Application No: F/24/97945
Description: Erection of 52 retirement living apartments with associated communal facilities and car parking; the erection of a pair of detached dwellings; improved vehicular access and new pedestrian access to Winchester Road.
Site: LAND ADJACENT TO OAK COTTAGE, WINCHESTER ROAD, BOORLEY GREEN, SO32 2DH,

Thank you for the amended plans. They have resolved a number of points, but some issues still need to be resolved as set out below.

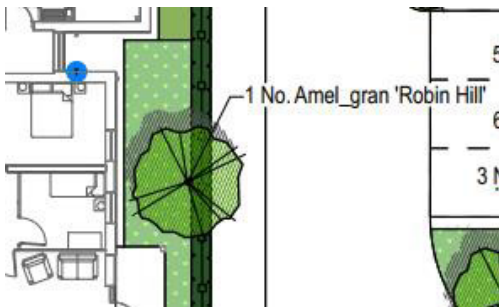
As set out in my previous letter, and in Urban Design's comments, the use of dark grey and grey roof tiles is not acceptable and needs to be changed to natural slates, together with the use of red plain clay tiles. – **accepted, we have changed the proposed materials to suit.** In addition the rendered elevations need to be changed to painted brick, as even though this may peel, it is easier to maintain as it can be repainted more easily than marked render can be cleaned. – **painted brickwork leads to more frequent defects and maintenance issues. Marked render can be painted and has more longevity than painted brickwork, meaning less regular maintenance, and in turn a more affordable service charge to residents.** Please amend drawing SO_2977_03_AC_031 accordingly as an improved palette of materials is required to ensure the development is in keeping with the quality of materials used on the adjoining Boorley Gardens development.

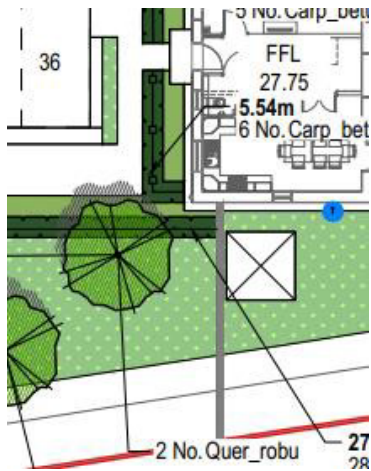
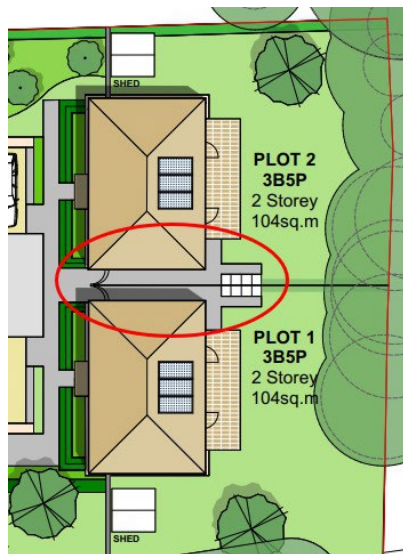
- A few trees are planted in locations with limited rooting zone. The species used here should be changed to robust species known to withstand such challenging conditions (varieties of Acer campestre & Carpinus). This applies to the 2 Prunus spp. adjacent parking bays 33 & 38 and also the 2 Betula spp. adjacent parking bay 21 and the substation. **We have changed to cherry trees (Prunus padus) adjacent bays 33/34/38/37 to smaller species with a similar flowering feature (Prunus 'Sunset Boulevard')**
The 3 trees next to the substation have bigger root zones but we have changed them all to "Acer campestre" as suggested by the officer.
- This Oak tree is too close to the building and should be repositioned so that it has room to grow. – **it has been moved away from the building.**

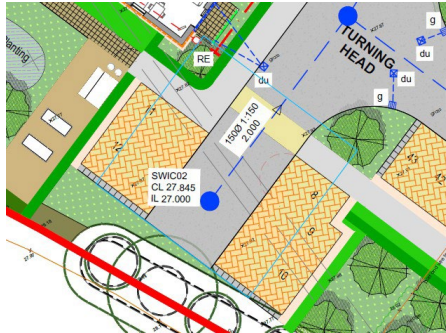
In amending the drainage layout please update the layout to show the latest site layout clearly (e.g. 2 alignments of the pedestrian link in the north-eastern corner are

visible) and amend the key to indicate what the light blue rectangles depict (see example extract below) as they were not on the previous version of the drawing.

- dwg updated with the latest site layout, the light blue rectangles have been removed.
